UNITED STATES PATENT AND TRADEMARK OFFICE

APPLICATION NO.	FILING DATE	FIRST NAMED INVENTOR	ATTORNEY DOCKET NO.	CONFIRMATION NO.
10/729,231	12/05/2003	Roger Thomas	P-US-PR 1107	9218

Office Action Summary	Application No.	Applicant(s)	
	10/729,231	THOMAS, ROGER	
	Examiner	Art Unit	
	Shelley Self	3725

DETAILED ACTION

FIG. 2

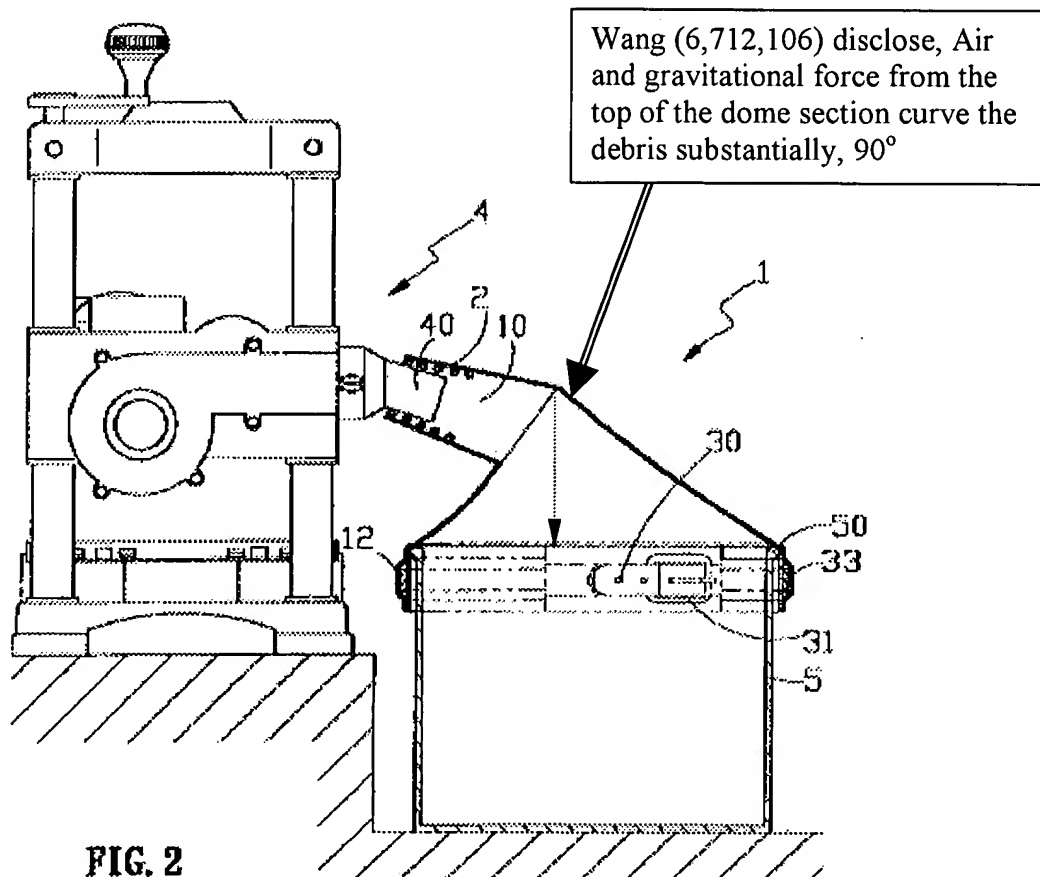
With regard to claim 15 and 16 as best as can be understood, Wang discloses a part spherical shaped section (10; fig. 2) that cures the path of the debris as it passes through the part spherical section.

As to the 90 degrees (clm. 16) Examiner notes that the spherical section (10) curves the path of the debris and that some of the debris will follow the spherical section (10) to a highest most point and fall by air and gravity force downward, i.e., at a 90 degrees (fig. 2).
